Date	04/09/2024
Subject	Addendum assessment and decision No.10 for proposed modifications to M1 Western Distributor Smart Motorway Project

Modification to the M1 Western Distributor Smart Motorway Review of Environment Factors (REF).

Appendix E: 100% Detail Design Phase WestConnex Interface Static Signs, as Prepared by Aurecon

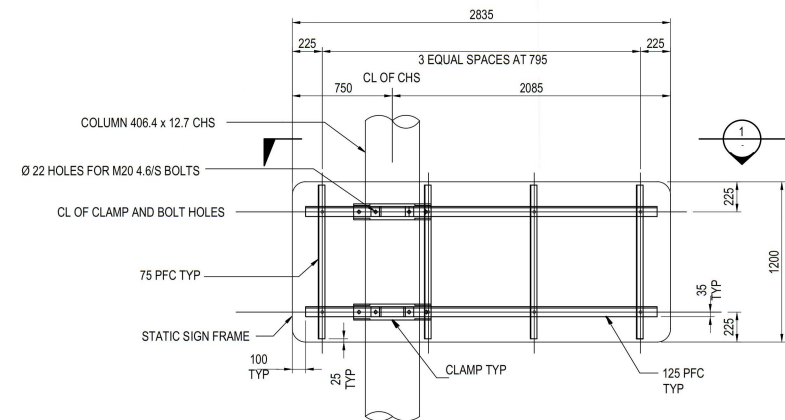
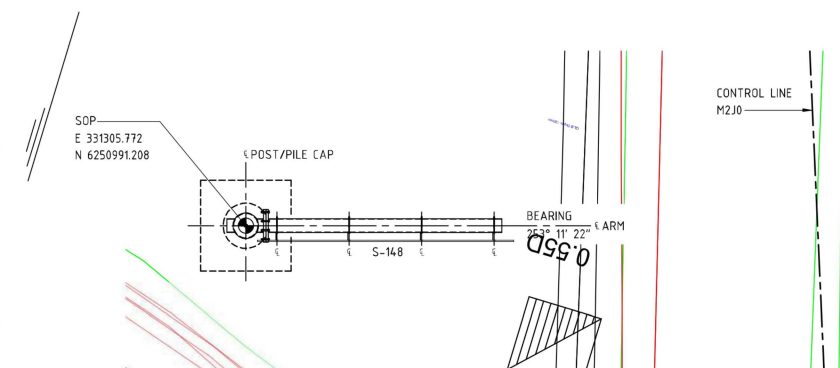
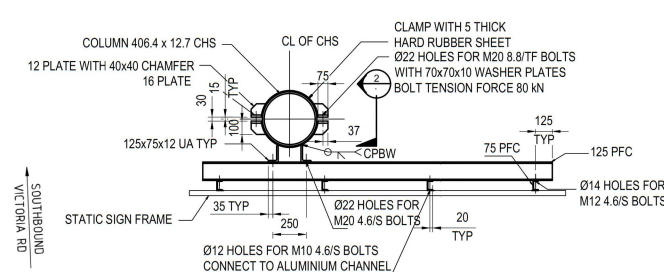
ID	Location	Description of road safety deficiency	Crash frequency	Crash severity	Level of risk	Action on risk to road safety (By persons/designer responsible)	Follow up and Close out (by Project Manager)
1	Sign 2 and 6	<p>Sign 2 and 6 appear to be set back from the road by over 4m, such a large offset reduce sign visibility for drivers and impact on compliance.</p> <ul style="list-style-type: none"> - Critical signs that demand immediate action from the drivers need to be noticeable and to ensure they command the attention of the driver. The signage placement may impact driver perception to the hazard ahead <div data-bbox="427 665 999 987" data-label="Image"> </div> <div data-bbox="418 1015 992 1386" data-label="Image"> </div>	Possible	Insignificant	Low	Noted. Due to complexity and limitations of the site, these locations have been suggested by TfNSW and NSS despite suboptimal visibility.

ID	Location	Description of road safety deficiency	Crash frequency	Crash severity	Level of risk	Action on risk to road safety (By persons/designer responsible)	Follow up and Close out (by Project Manager)
4	Sign 2	<p>Mounting height appears higher than standard speed device mounting height which could result in non-compliance to TfNSW sign mounting specifications.</p> <ul style="list-style-type: none"> - Non-compliance to specifications could result in non-desirable driver perception / poor visibility 	Unlikely	Minor	Low	Sign was placed higher due to potential obstruction from the RC1 in front.	
5	Sign 5	<p>Following on from comment 4, there may be too much information at this location for drivers if the variable speed sign is operating (two speed limits showing, several signs)</p> <ul style="list-style-type: none"> - The team presumes an assessment/risk assessment has been undertaken by the designer to ensure compliance to specifications or have documented non-compliances. 	Unlikely	Minor	Low	Electronic signs is an RC1, used for lane control. Co-location of multiple signs has been recognised and approved by NSS.

SIGN 5 ELEVATION FRONT VIEW
SCALE 1:20

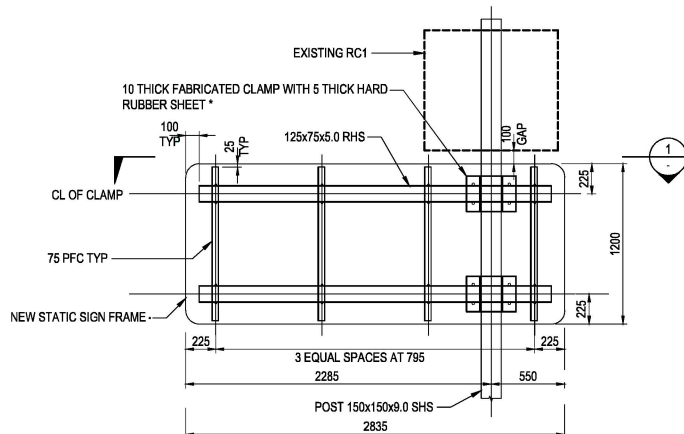
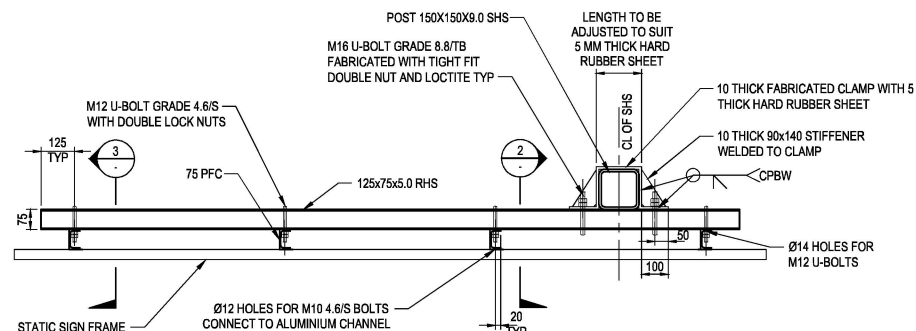
6	Sign 4 and 5	<p>Potential sign masking issue between sign 4 and 5.</p> <ul style="list-style-type: none"> - Its not clear if there is sufficient distance between the two signs allowing drivers to process information - Late weaving or side swipes could occur <div data-bbox="461 437 1111 815"> <p>SIGN 4</p>  </div> <div data-bbox="461 868 1111 1289"> <p>SIGN 5</p>  </div>	Unlikely	Minor	Low	<p>This is a recognised limitation of the site. It has been noted the relatively low importance of these signs. The information contained on these signs should not prompt drivers to late weave.</p>	
---	--------------	--	----------	-------	-----	---	--
